APPLICATION NO.	FILING DATE	FIRST NAMED INVENTOR	ATTORNEY DOCKET NO.	CONFIRMATION NO.
10/802,653	03/17/2004	Heinz Eisenschmid	10191/3456	3928
26646	7590	12/22/2005	EXAMINER	
KENYON & KENYON ONE BROADWAY NEW YORK, NY 10004			ROGERS, DAVID A	
			ART UNIT	PAPER NUMBER
			2856

Office Action Summary	Application No.	Applicant(s)	
	10/802,653	EISENSCHMID ET AL.	
	Examiner	Art Unit	
	David A. Rogers	2856

DETAILED ACTION

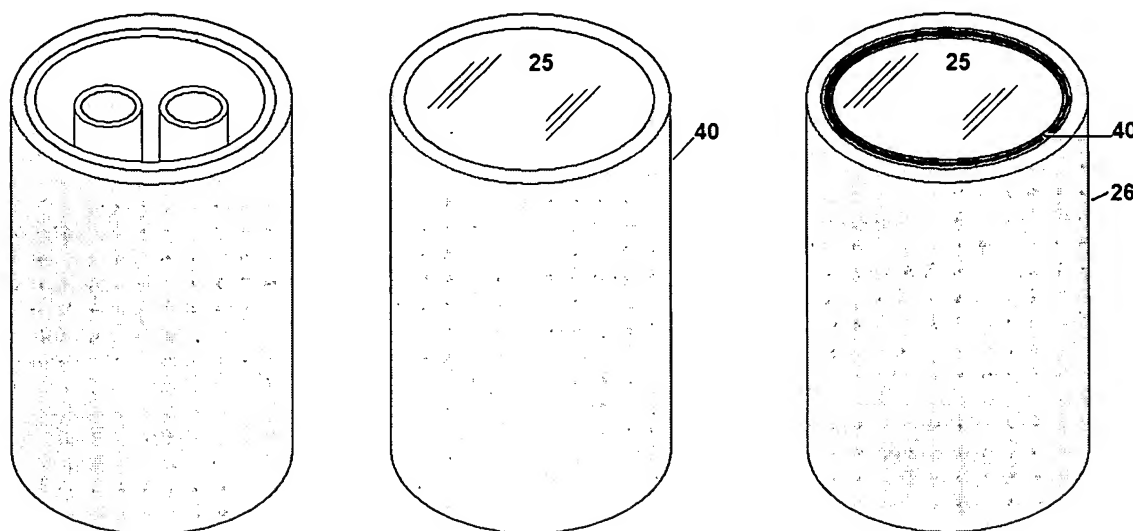
The drawings are objected to because figures 3-7 do not reasonably convey the disclosed structure. For example, figure 3 (reference item 20) should show the wall thickness and the coating thickness as shown in the example below. The individual rods should also be shown in an enlarged view as shown in the examples below. The remaining figures should be amended accordingly.

Corrected drawing sheets in compliance with 37 CFR 1.121(d) are required in reply to the Office action to avoid abandonment of the application. Any amended replacement drawing sheet should include all of the figures appearing on the immediate prior version of the sheet, even if only one figure is being amended. The figure or figure number of an amended drawing should not be labeled as "amended." If a drawing figure is to be canceled, the appropriate figure must be removed from the replacement sheet, and where necessary, the remaining figures must be renumbered and appropriate changes made to the
